# Development Services

### APPEAL SUMMARY

<b>Appeal ID:</b> 20211	<b>Project Address:</b> 3720 N Vancouver Ave
<b>Hearing Date:</b> 4/10/19	<b>Appellant Name:</b> Brannon Soens
<b>Case No.:</b> B-010	<b>Appellant Phone:</b> 503-360-1437
<b>Appeal Type:</b> Building	<b>Plans Examiner/Inspector:</b> Brian McCall
<b>Project Type:</b> commercial	<b>Stories:</b> 4 <b>Occupancy:</b> M & B <b>Construction Type:</b> III-B
<b>Building/Business Name:</b>	<b>Fire Sprinklers:</b> Yes - Fully-Sprinklered
<b>Appeal Involves:</b> Erection of a new structure	<b>LUR or Permit Application No.:</b> 18-258454-CO
<b>Plan Submitted Option:</b> pdf [File 1] [File 2] [File 3] [File 4]	<b>Proposed use:</b> Mercantile/Office

EXHIBIT 1 - ROOF PLAN

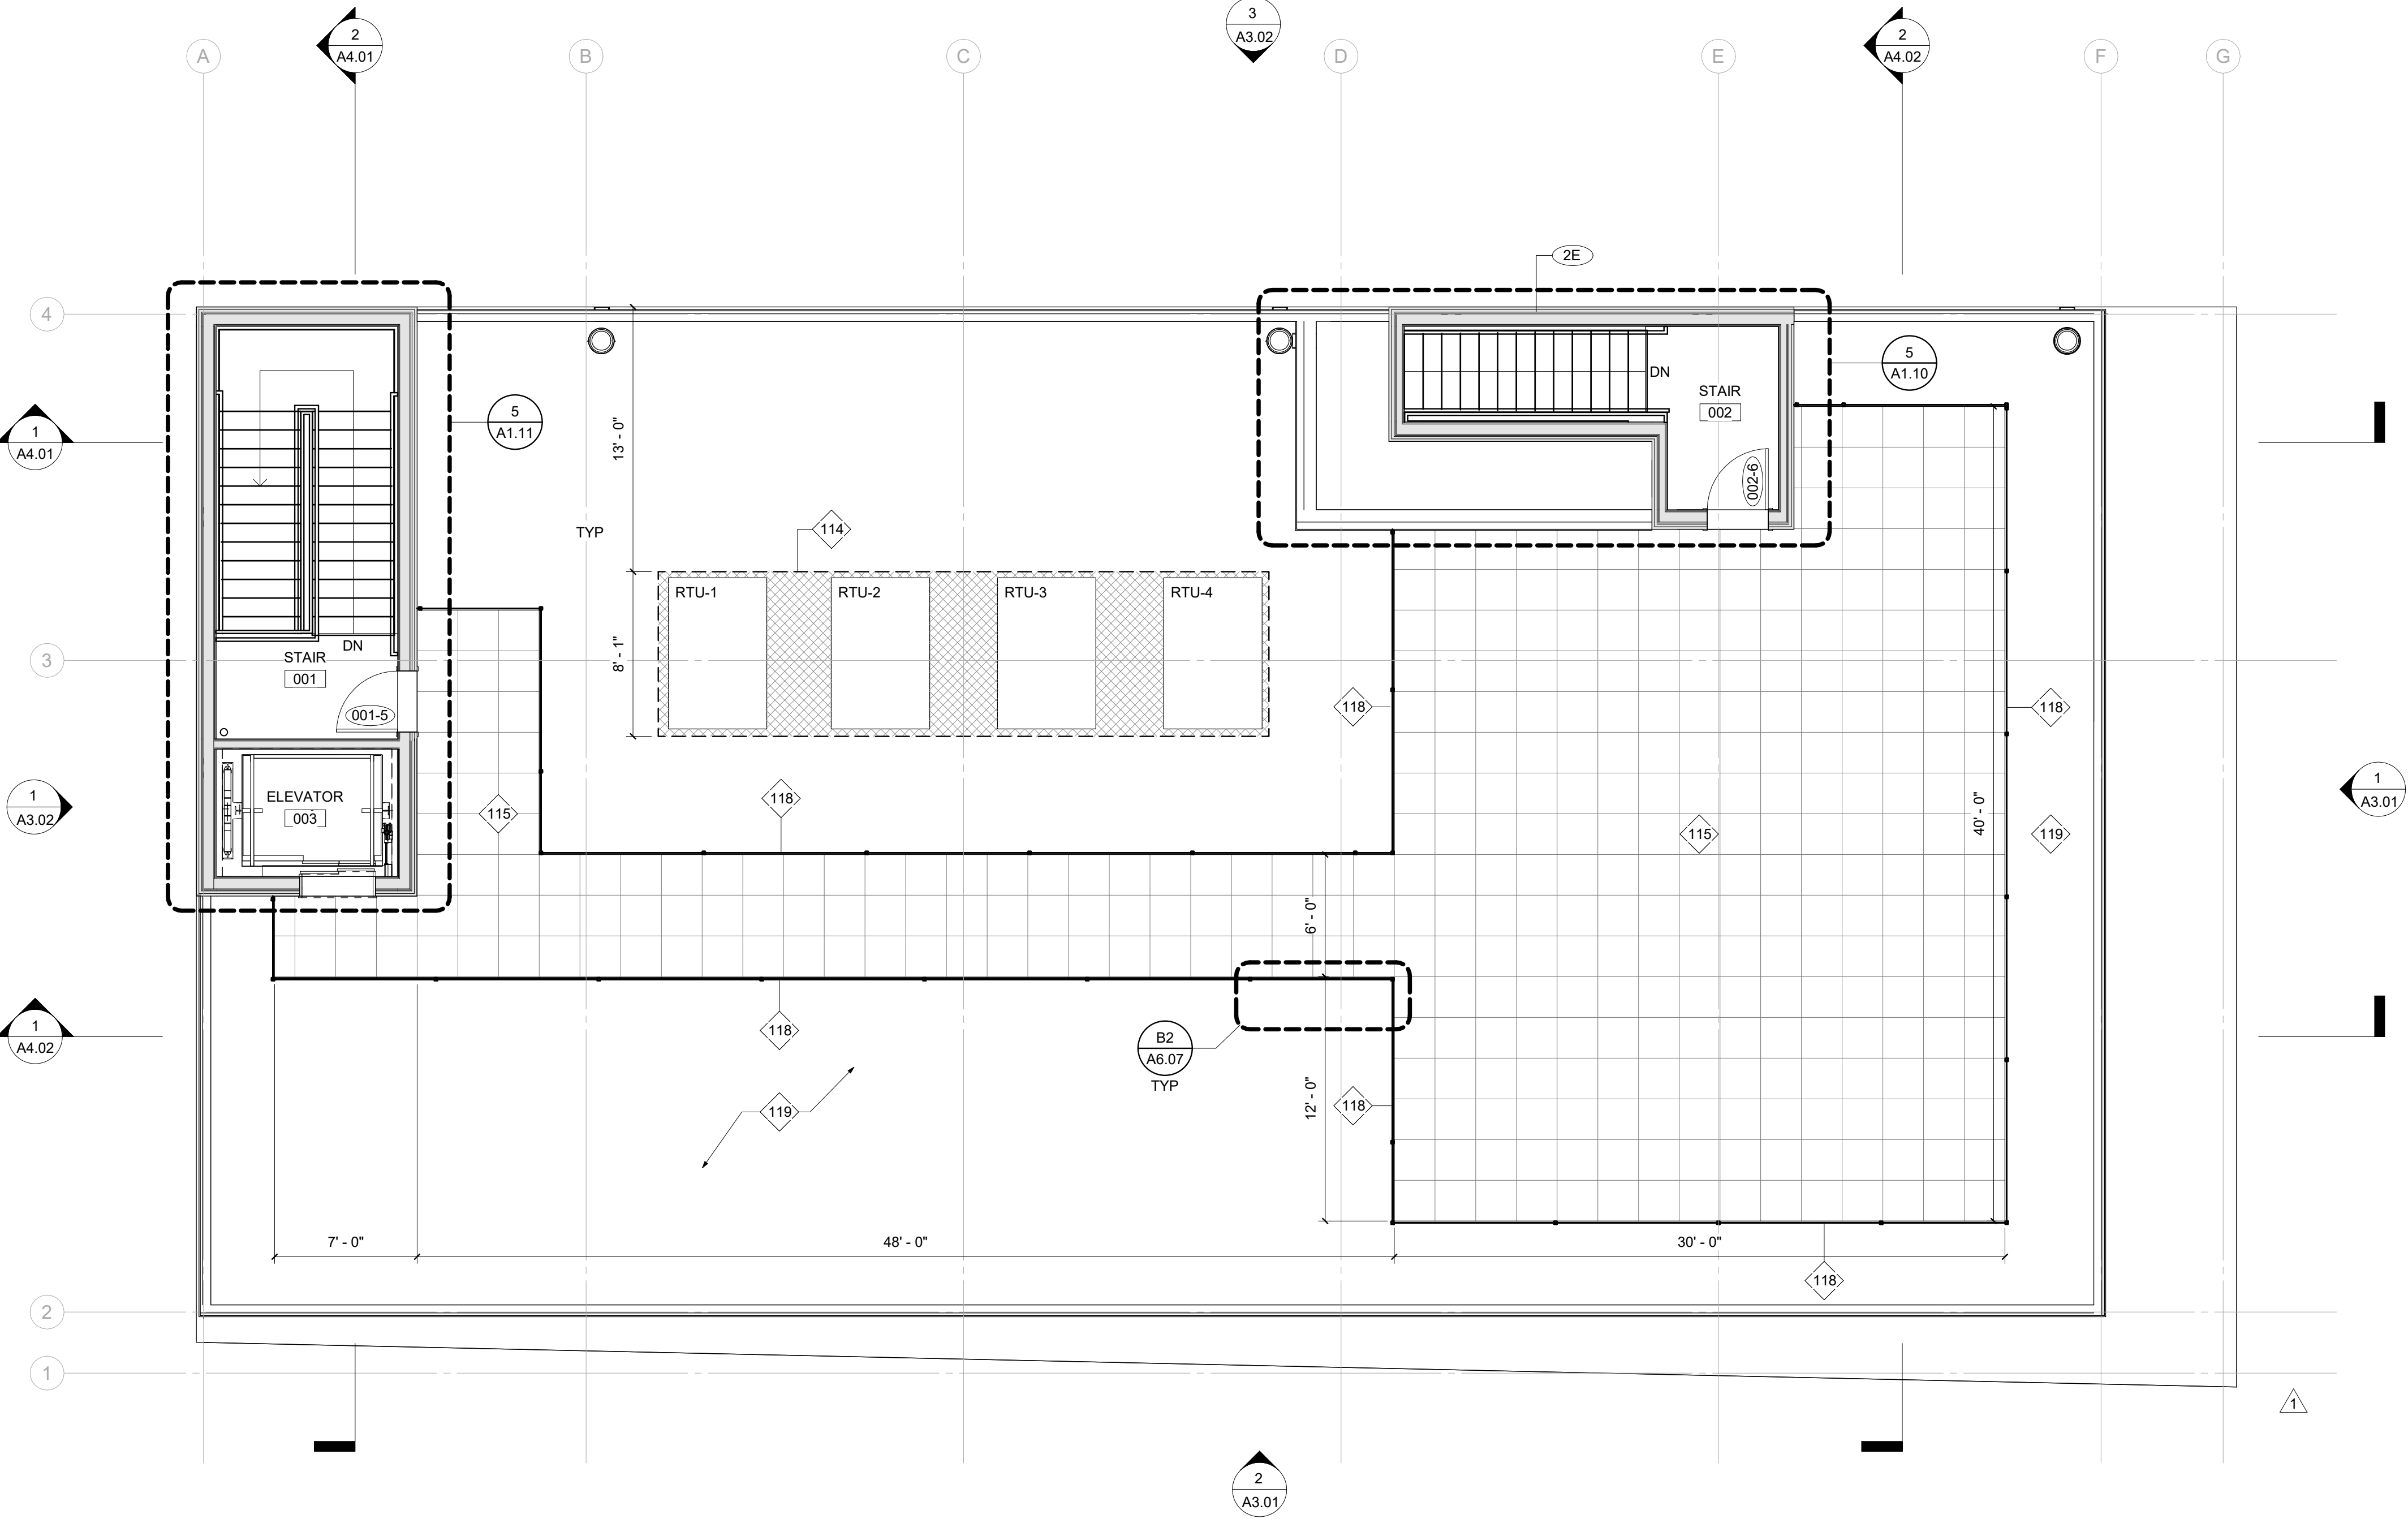
**Code Section** OSSC 2014 Section 1007.2.1

**Requires** Elevators required. In buildings where a required accessible floor is four or more stories above or below a level of exit discharge, at least one required accessible means of egress shall be an elevator complying with Section 1007.4.

**Proposed Design** The proposed design is a 4-story building on a flat site. We are proposing an occupied roof, with accessible means of egress from the occupied roof provided by two exit stairways complying with Sections 1007.3 and 1022.

The occupied roof will not be covered or enclosed, and will not have a roof or walls over 48" high. The building is equipped throughout with an automatic sprinkler system installed in accordance with NFPA 13 and OSSC Section 903.3.1.1.

See attached roof plan (Exhibit 1) and building section (Exhibit 2).

**Reason for alternative** OSSC 2014 Section 1007.4 requiring an elevator as an accessible means of egress does not pertain a four-story building with an occupied roof. An occupied roof is not considered a "story" or a "floor."

**1. Omission of elevator back up power to occupied roof level deck: Granted as proposed.**

**EXHIBIT 4 - SECTION DETAIL**

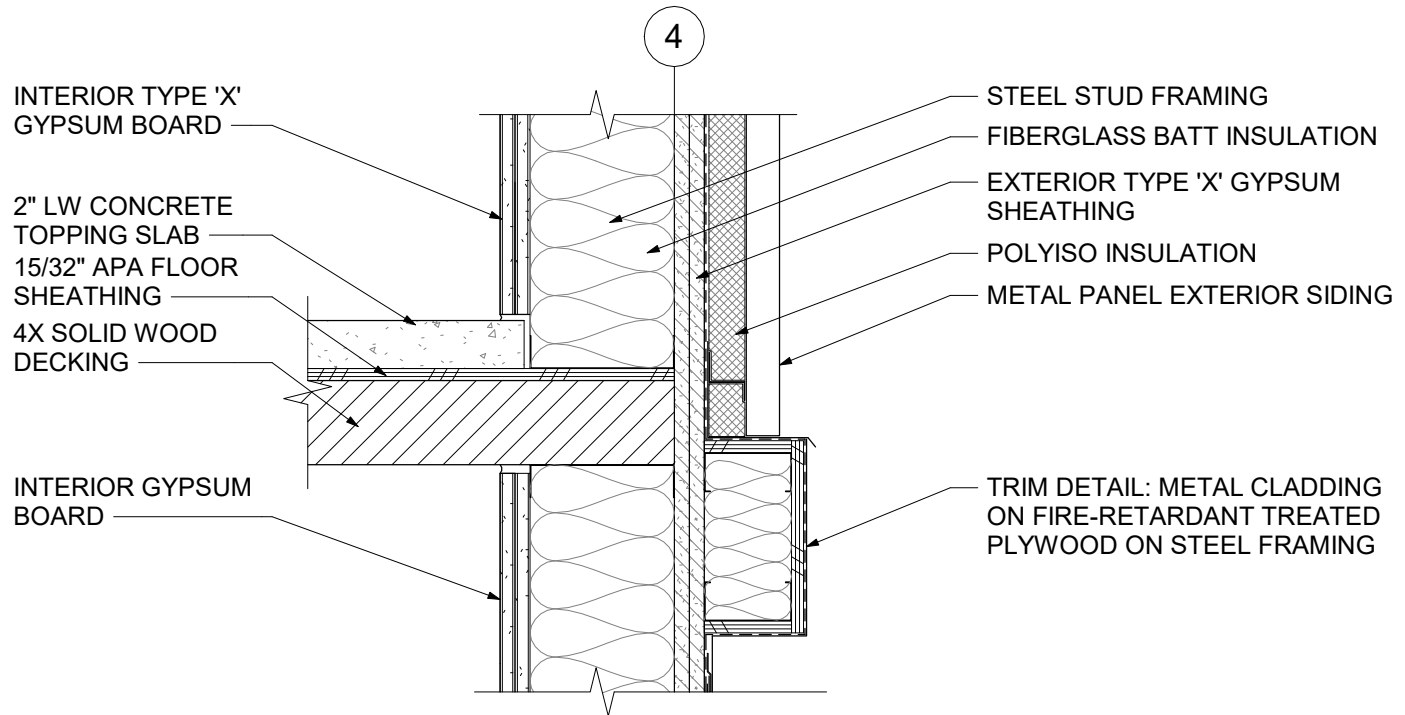
<b>Proposed Design</b>	<p>The proposed design is a 4-story, Type IIIB, building with ground level mercantile space and three levels of office above. The proposed floor and ceiling construction is exposed glulam beams and solid 4x wood decking supported by steel columns. Floors will receive a lightweight concrete topping slab over structural sheathing. Exterior walls are framed with 6" steel studs and sheathed with noncombustible gypsum sheathing. The building is fully-sprinklered per NFPA 13.</p> <p>The solid wood decking and sheathing extends into the exterior wall assembly at the floor and roof levels (Exhibit 4). All framing, sheathing and siding materials are noncombustible.</p>
------------------------	----------------------------------------------------------------------------------------------------------------------------------------------------------------------------------------------------------------------------------------------------------------------------------------------------------------------------------------------------------------------------------------------------------------------------------------------------------------------------------------------------------------------------------------------------------------------------------------------------------------------------------------------------------------------------------------------

<b>Reason for alternative</b>	The wood decking is a primary design feature of the building and will be exposed in all interior locations. The floor structure and structural frame is not required to be rated per OSSC Table 601, Type IIIB.
-------------------------------	-----------------------------------------------------------------------------------------------------------------------------------------------------------------------------------------------------------------

The condition we are proposing, where the solid 4x wood decking and sheathing intersects the noncombustible exterior wall is very similar to the CLT condition allowed by the 2015 & 2018 code language. The exterior surface of the decking/sheathing is protected by gypsum interior wall finish and gypsum exterior sheathing. All surrounding framing and finish materials are noncombustible. Fiberglass insulation is provided between studs. The sprinkler system will provide an additional level of protection.

**2. Combustible material within Type III exterior walls: Granted provided the intersection between the floor assembly and the interior face of the exterior wall is detailed as part of a listed, tested assembly.**
